Economic Commission for Europe**Inland Transport Committee****Working Party on the Transport of Dangerous Goods****Joint Meeting of the RID Committee of Experts and the
Working Party on the Transport of Dangerous Goods**

Geneva, 17–27 September 2019

Tanks**Tanks: Interpretation of construction requirements
applicable to the opening ends of Vacuum-Operated Waste
Tanks (VOWTs)****Transmitted by the Government of the United Kingdom* *****Summary*

- (a) Manual hand wheel door clamps:

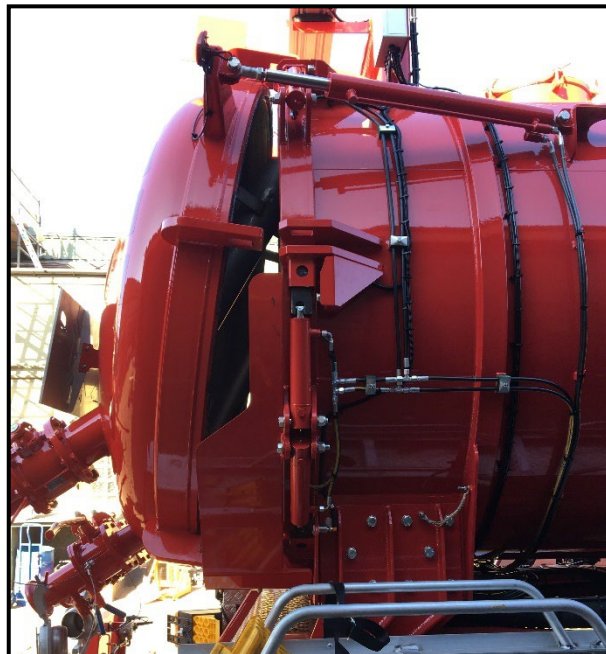
The clamps are protected by the substantial brackets on the tank and door from damage during a roll-over. In the event of a roll-over occurring the hand wheels are designed to fracture and leave a nut securing the door in place, thus preventing the door from being forced open.

It should be noted that, as required by ADR 6.10.3.5 (d), the locking arrangement shown below incorporates a safety device to prevent the door opening when there is still residual pressure in the tank.

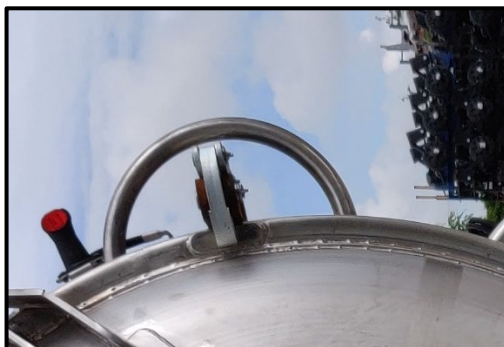
8. With regards to the requirement in 6.10.3.5 (e) for provisions that prevent the door being forced open in the event of a roll-over, our view is that this would be met by examples (a) and (b) but not example (c). The door clamping mechanisms in example (c) would appear to be vulnerable to circumferential forces in the event of a roll-over incident and likely to be subject to damage that might force the clamps and therefore the door open. In our opinion, therefore, example (c) would not seem to meet the requirements of 6.10.3.5 (e).

9. However, should the locking mechanism shown in example (c) be protected, as shown in the image below, in our opinion the requirements of 6.10.3.5 (e) for any door locking mechanism must be designed in such a way that it is protected against being forced open in the event of a roll-over would be fulfilled.
